North Mesa Picnic Grounds

**280 N Mesa Rd
Los Alamos, NM 87544**

Accessibility Evaluation

***Inspection Date: 11/03/2021
Inspector: Jay Rhodes***

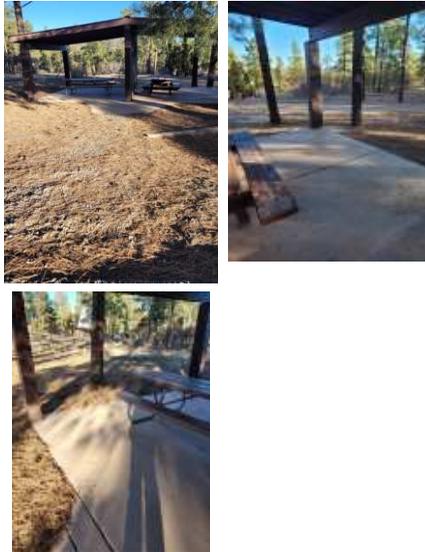
Finding Number	Area Description	Lat/Long	Finding	As Built	Recommendation	Citation	Photos	Figure
16	Park Site: Shelters/ Pavilions	[35.89615, -106.2934]	The walkway contains abrupt vertical edges and/or variations over a 1/4 inch. 1/4 inch is the maximum vertical rise. Changes in level between 1/4 inch and 1/2 inch must be beveled at 1:2 or less. Changes in level greater than 1/2 inch must be by way of a ramp.	CIL of 1"	Repair, bevel or ramp CIL along AR.	2010 ADAS Section: 303.3, 303.2 1991 ADAS Section: 4.5.2	 	
17	Park Site: Shelters/ Pavilions	[35.89615, -106.2934]	Where picnic facilities contain two or fewer picnic units, each picnic unit shall provide mobility features complying with F245.2.	Lacks AR to garbage can, 1 of 4 grills lacks AR	Relocate 20% of garbage cans to be along AR. Reposition grills to be accessed from existing shelter cement slab.	2015 ABAAS Section: F245.2.1
